Re: The current HLC design does not meet all Conditional Use Permit CU# 02-20 requirements

Eagle Drive Fairway Drive Modified 2nd Floor Site Views

Below is the applicants sketch used at the final January 25, 2021 Conservation Commission meeting for CU#02-20.

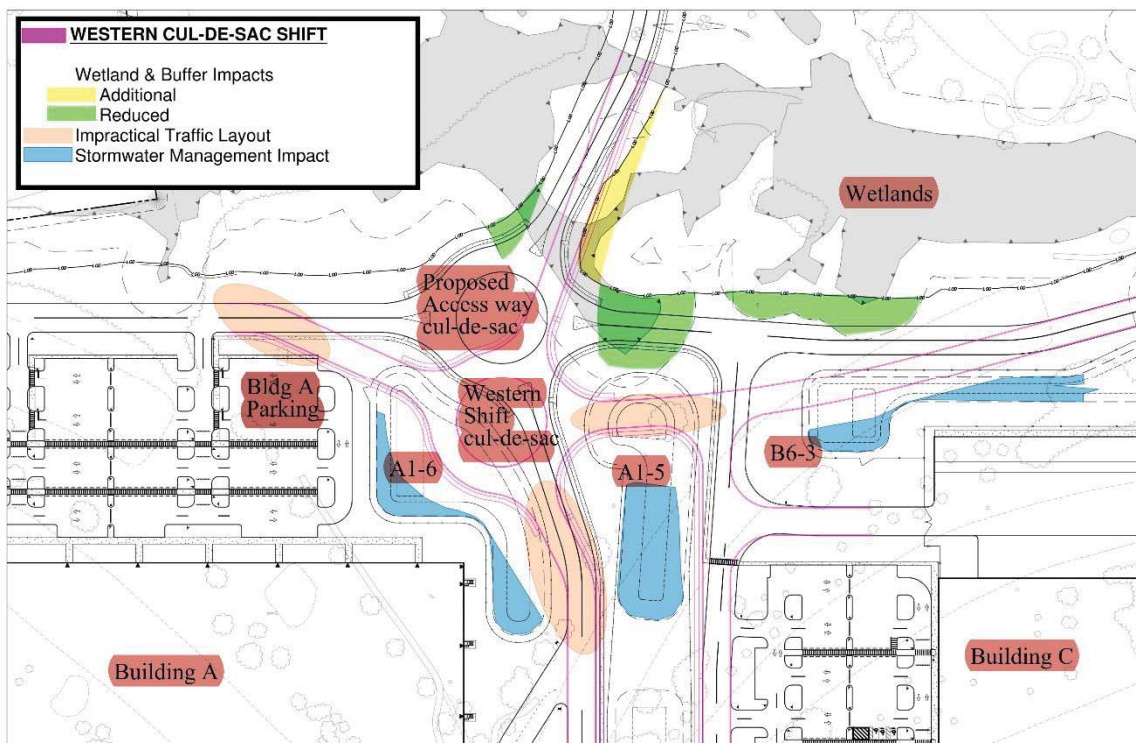
I have added the YELLOW highlighted titles. So now for the details as to why the current plans which still are not complete after about 8 months of review from the first application acceptance meeting to now after multiple revisions, still do not fully comply with Town Code 334-36(C) (2).

- My allowed response was limited to pretty much stating that alternative modifications to the Stormwater Management System and Site roadway design could be properly engineered to bring the access way into full compliance with 334-36(C) (2) and a viable alternative did exist. The Chairman, Mr. Collins suppressed future comments concerning what design changes could be made to the plans to minimize wetlands impacts. I will state right here that MR. COLLINS WAS CORRECT IN DOING SO. He explained the Conservation Commission can only submit stipulations to the Planning Board on plans presented to them for review but are not authorized to make alternate design recommendations to the Planning Board. However, Mr. Collins and the Town Engineer could and did recommend I take my opposition to the current alignment to the Planning Board.

The following is my more complete presentation to Planning Board as to why the plans do not adhere to 334-36(C) (2) and the Applicants statements are not completely creditable. To do so below is Sketch Western cul-de-sac shift presented by the Applicant at the January 25, 2021 Conservation Commission meeting. The RED highlighted text was added by me for clarification purposes.

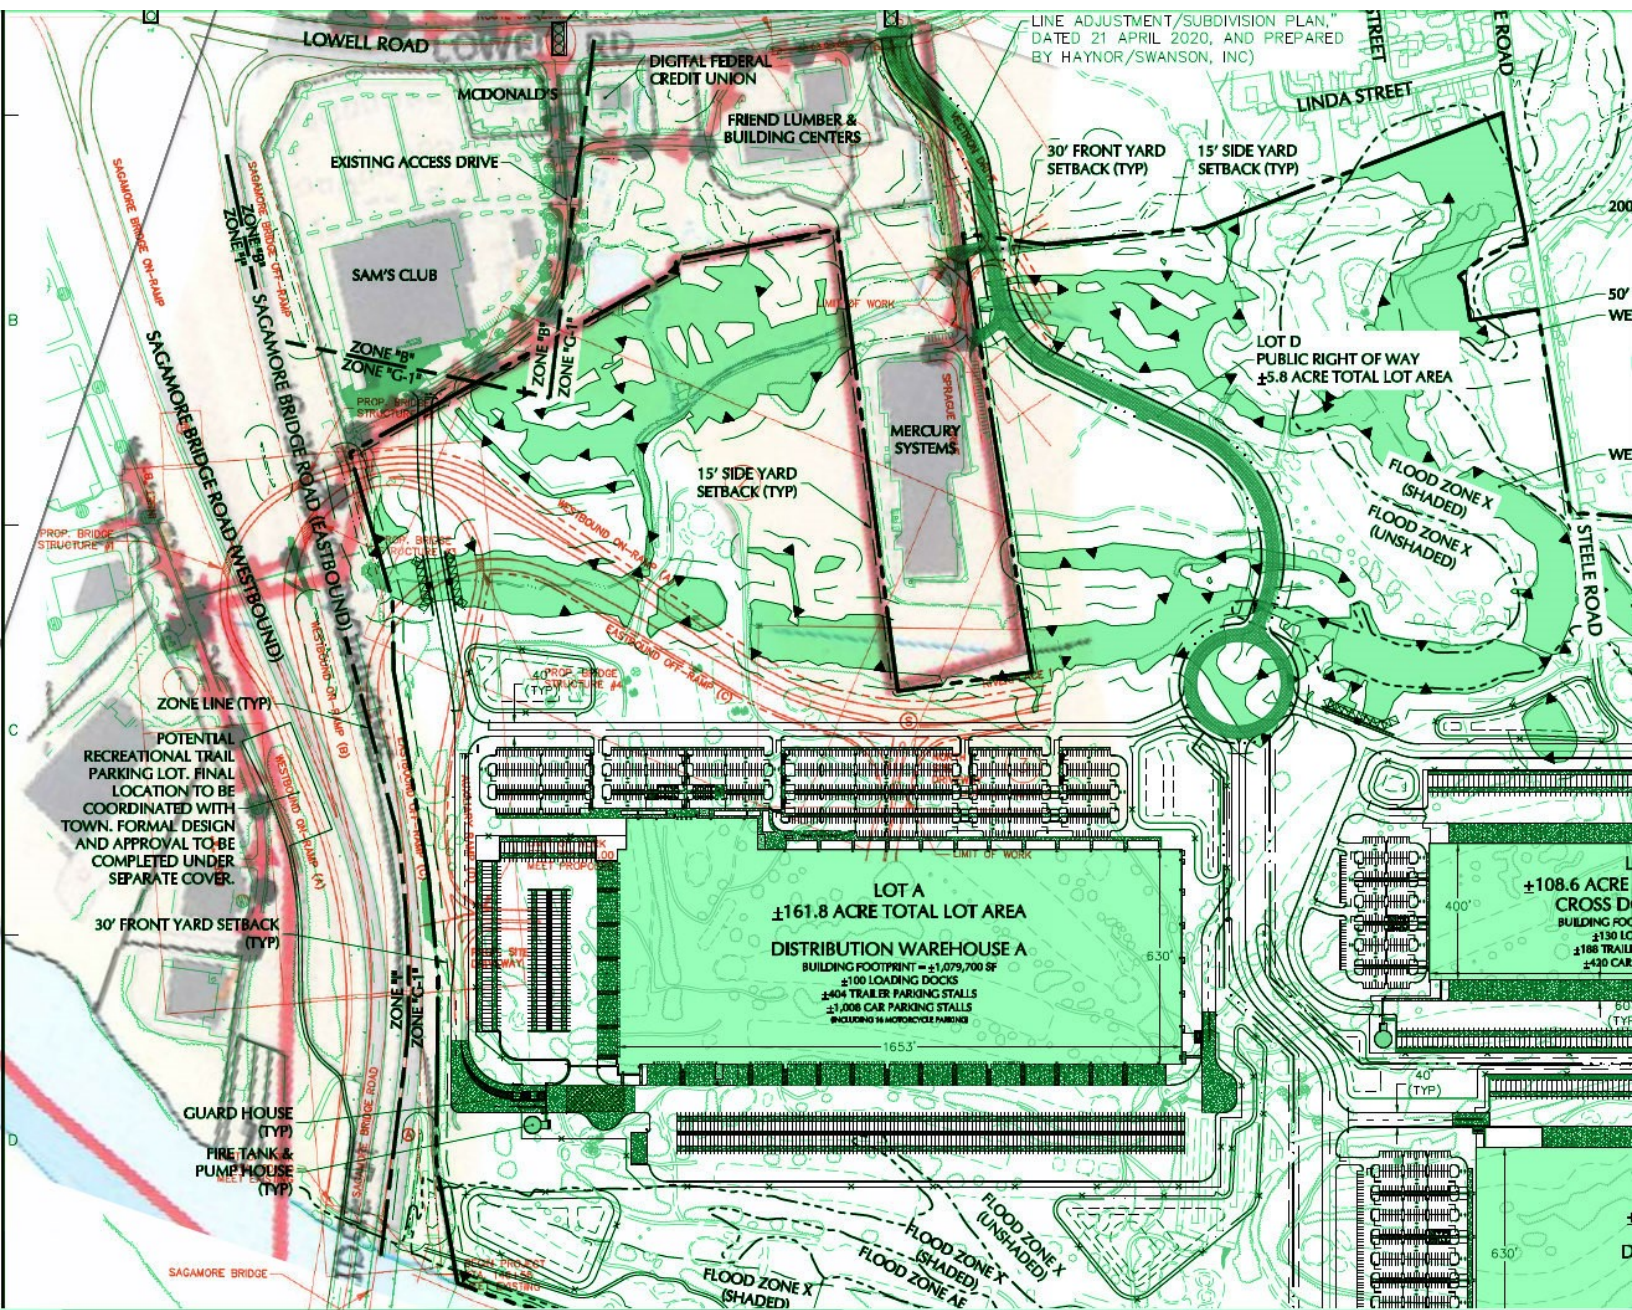
Note that the sewer pipe segmented line ends up being made a bit more wide than other lines, but the center point of the sewer line, when compared with the black border line provided by the Hillwood to DOT site plan, shows that the sewer pipe itself seems to stay outside of the golf course property, at that most critical property line corner!

8) If there is a NH DOT prohibition of even a huge and dominant road usage source as the proposed Hillwood project is just a private commercial user, and cannot possibly be given a dedicated exit or entrance, the above conversion to the golf course land being converted to a public roadway, to connect Walmart Blvd with both Eastbound and Westbound Sagamore Bridge Roadway, this problem is avoided. NH DOT can now authorize the re-routing of the entrances and exits as a strictly public road, that just so happens to be exactly what River Place thought was best for their project.

8 Eagle Drive – 2nd Floor View

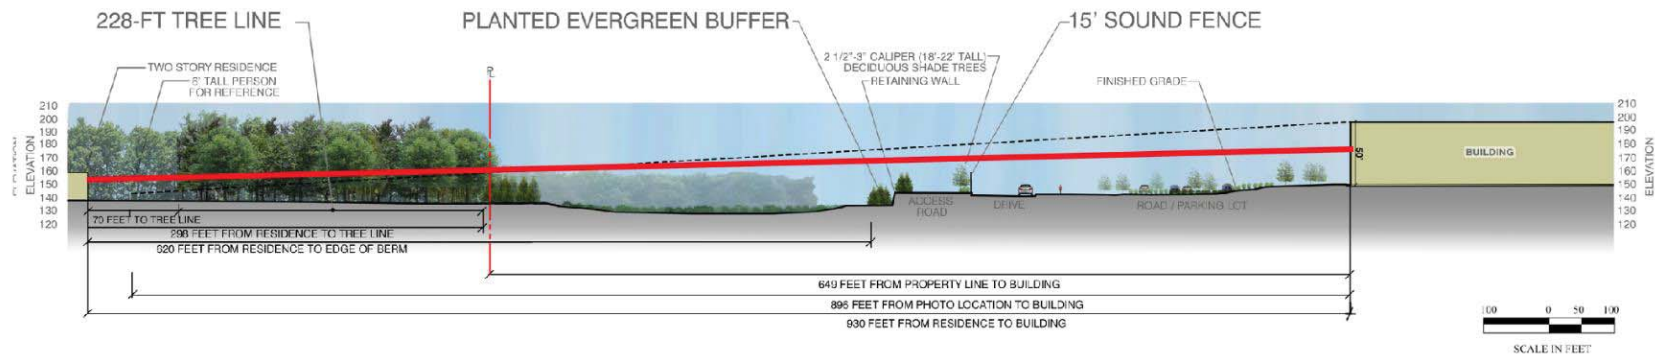
- Mature Trees will take many years to grow and immature trees will provide lower sight lines over the berm and sound wall
- Developer did not provide a view from the Fall and Winter with no leaves on the trees

11 Fairway Drive – 2nd Floor View

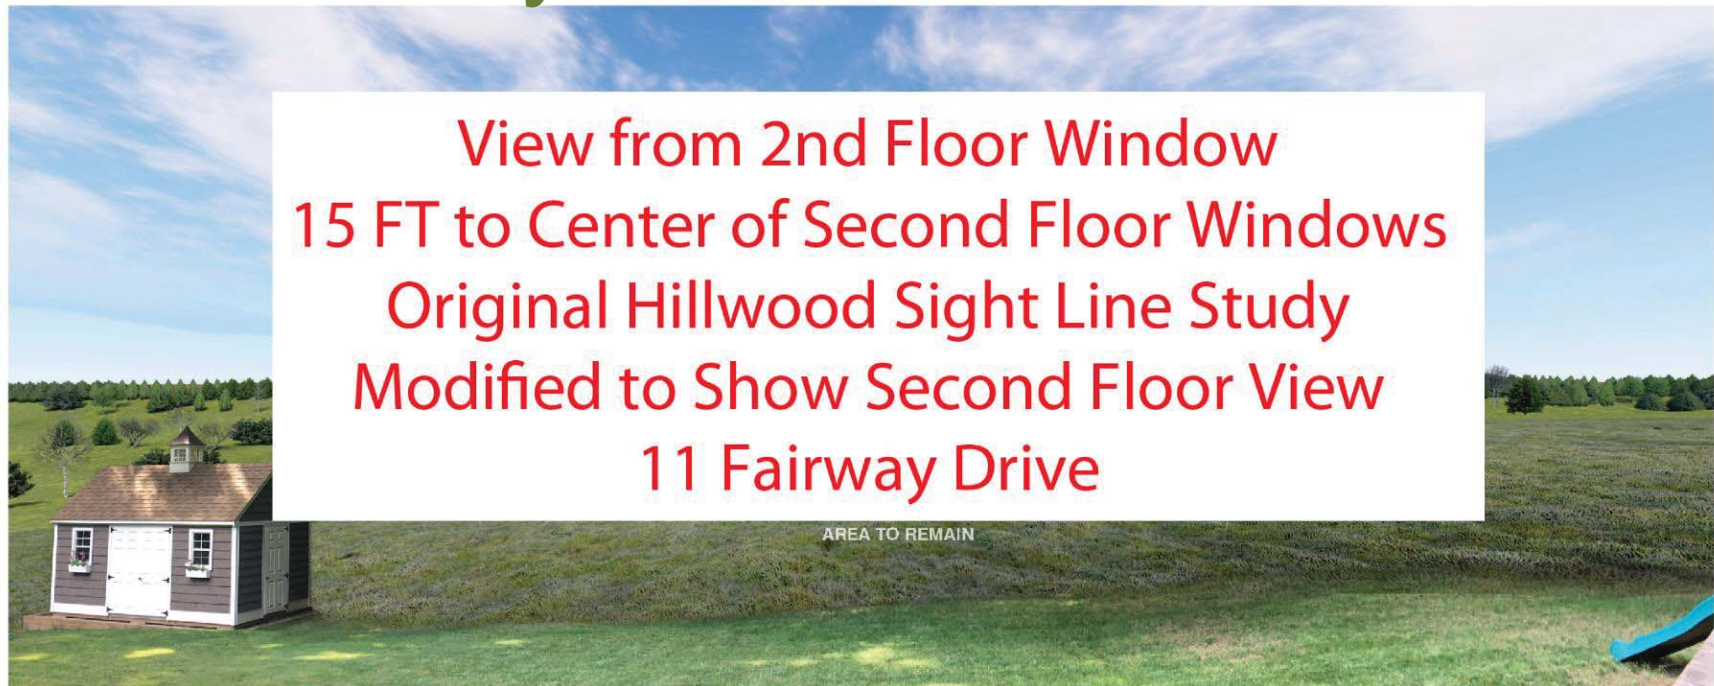
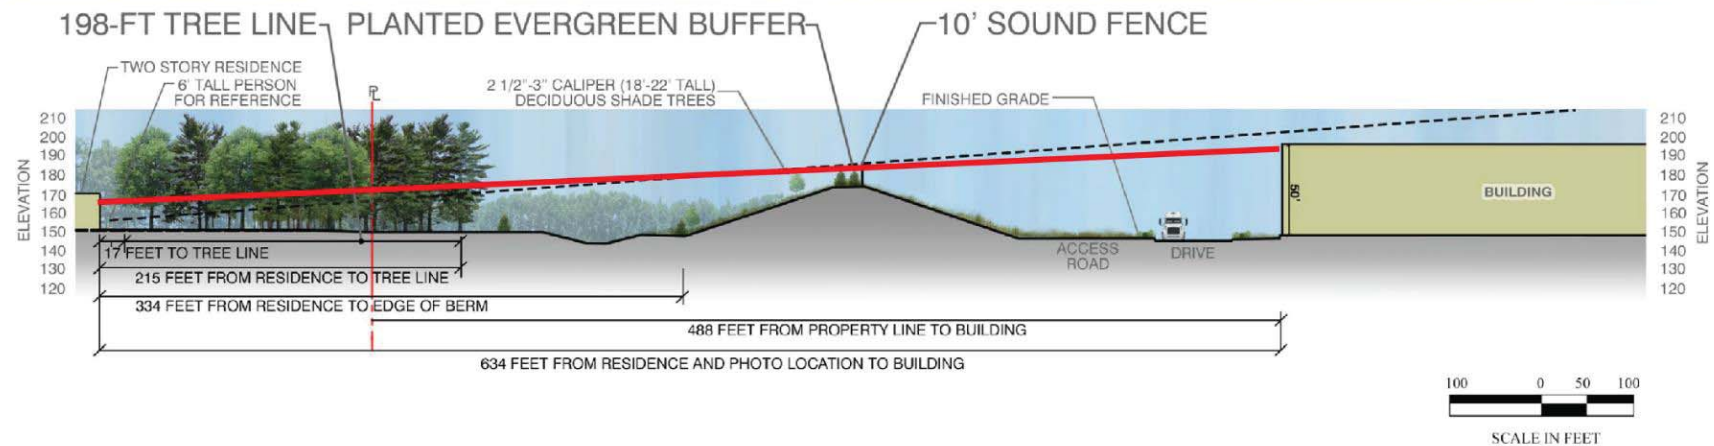
View from 2nd Floor Window
 15 FT to Center of Second Floor Windows
 Original Hillwood Sight Line Study
 Modified to Show Second Floor View
 11 Fairway Drive
